## Planning Commission Staff Report

October 17, 2011  
Item 4.b.

- SUBJECT:** PUD-85-08-12D (Site 1) / PUD-81-30-86D (Site 2)
- APPLICANT:** Bob Linder / BRE Properties, INC.
- PROPERTY OWNERS:** WP Carey (Site 1) and BRE Properties Inc. (Site 2)

- PURPOSE:** Work session to review and receive comments on two applications for PUD (Planned Unit Development) Development Plans to construct: (1) a mixed-use high-density residential/commercial development containing 251 residential units, four live/work units, and approximately 5,700 square-feet of retail space (PUD-85-08-12D); and (2) a high density residential development containing 247 residential units and four live/work units (PUD-81-30-86D).

**Figure 2: Site 1**

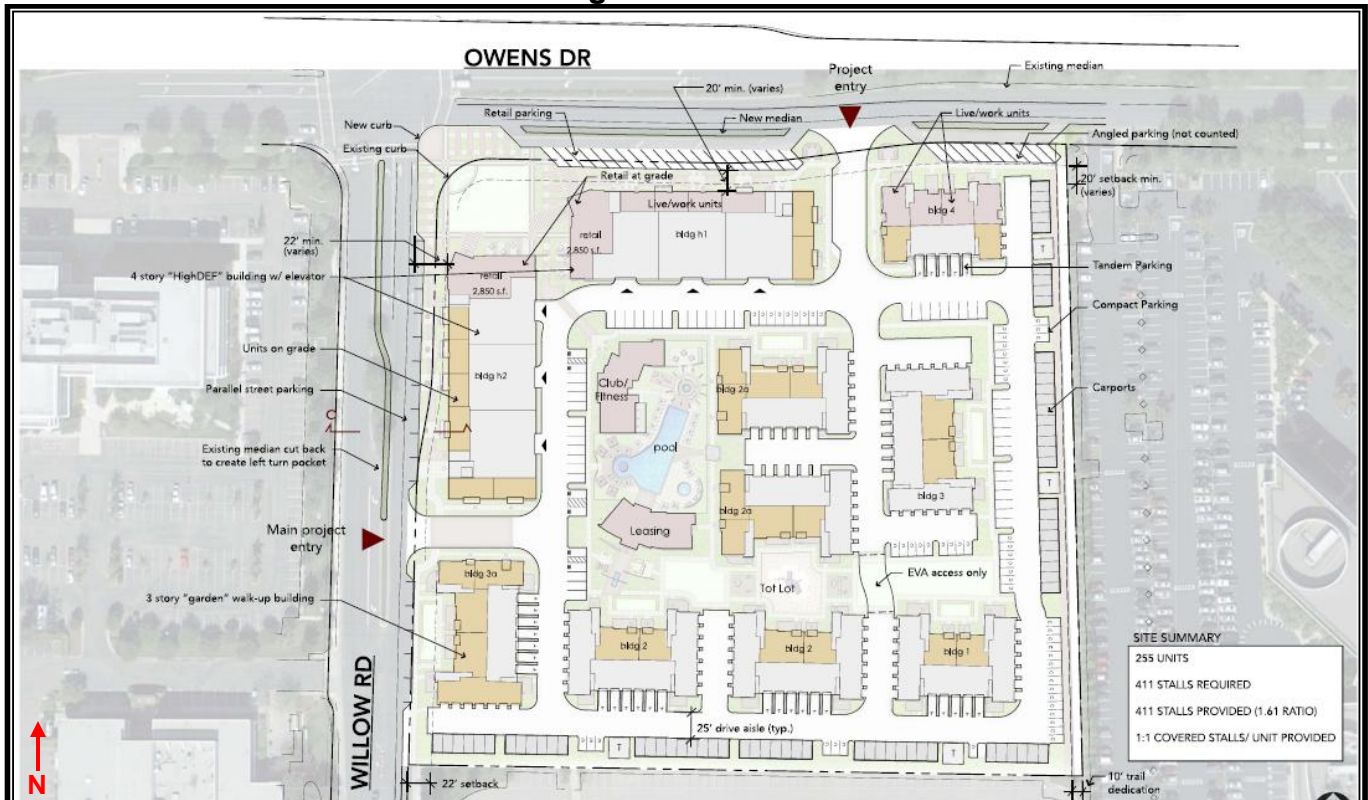
2. Site 1 does not meet the setback on the east side of Willow Road. Specifically, building H2 does not have an 8-foot planting strip setback from the curb as required in the Guidelines.

6. The median strip that separates Owens Drive from the diagonal parking should incorporate shrubs for screening. The guidelines require parking to be screened by low walls and landscaping.

8. The retail spaces on Site 1 have a 14-foot floor-to-floor height which does not meet the interior 15-foot clear floor-to-ceiling height requirement.

11. The live/work units on Site 1 (building H1) do not meet the minimum storefront depth of 40-feet. Furthermore, as proposed, it does not appear that the live/work units could later be converted to retail or service uses given the proposed depth.

20. The buildings on Site 1 lack a clear top architectural element. Staff suggests enhancing the top of the buildings architectural treatment. The addition of parapet caps should be incorporated into the project to show shadow lines and provide a contemporary top or cap to the buildings.

**Figure 3: Site 2**

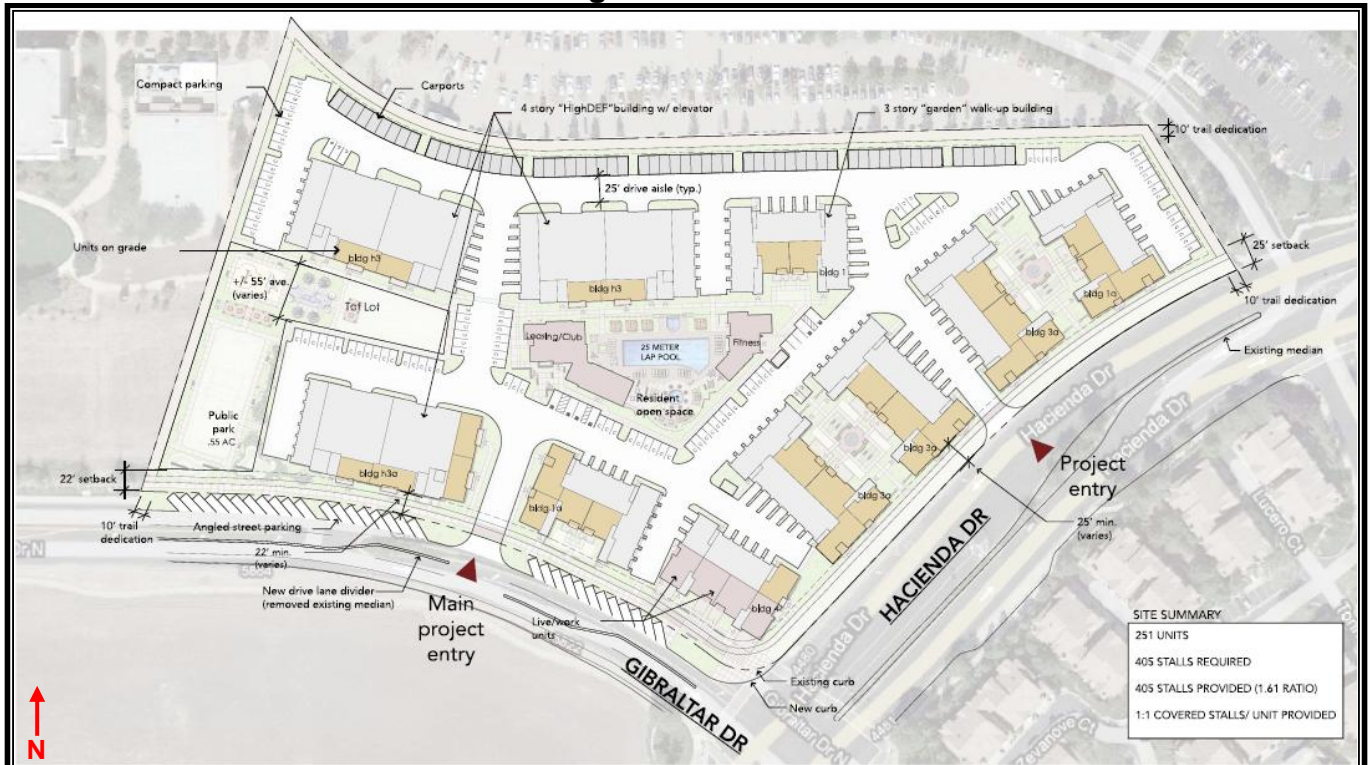
1. The minimum setback requirements are 10-feet for a planting strip, 6-feet for a sidewalk, and 9-feet for "privacy" setbacks. The privacy setback along Hacienda Drive (Site 2) is less than 9-feet.

4. As proposed, parking and garage doors face the public park and tot lot on Site 2. In addition, building H3 would be highly visible from Gibraltar Drive when traveling east and, therefore, should face the public park and have habitable space on its southwest corner as discussed in the Guidelines.

10. The live/work units for Site 2 do not meet the minimum 50% requirement of building frontage along Gibraltar Drive.

21. The “caps” on some of the buildings on Site 2 are successful architectural elements. It should be demonstrated in plan form where they will occur to determine if more “caps” are necessary.
